Seepage Loss Review Memo

RE: Recalculation of volumes associated with 87-12314

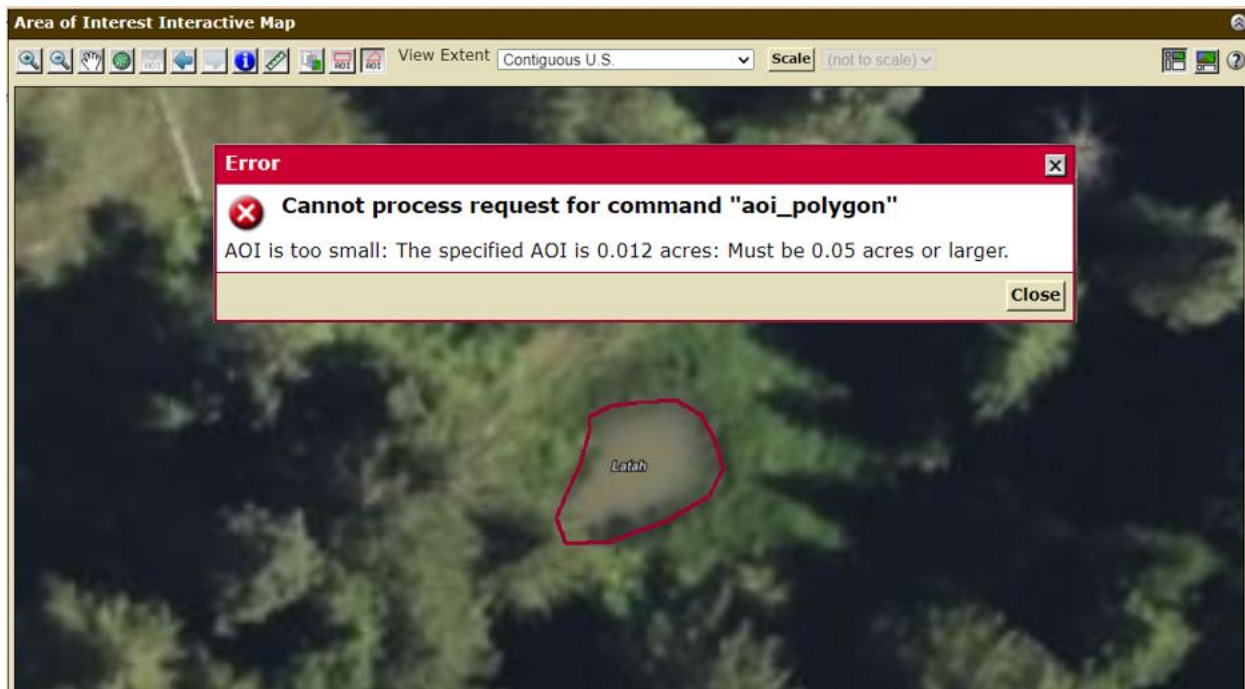
When recalculating seepage loss, I was able to use the NRCS aerial photos to measure a more accurate surface area of the pond. The pond surface area was measured at 0.012 acres. Previous seepage loss calculations used a pond surface area of 0.02 acres.

The red boundary surrounding the pond calculates to 0.012 acres. This area was too small for the NRCS tool to establish an Area of Interest, but it shows the surface area of the pond.

Calculated Seepage losses based on a pond with a 0.012 acre footprint (surface area) which was measured using tools provide by the NRCS, with a soil type classification of SM, results in seepage losses up to 0.88 AFA **~0.9 AFA**.
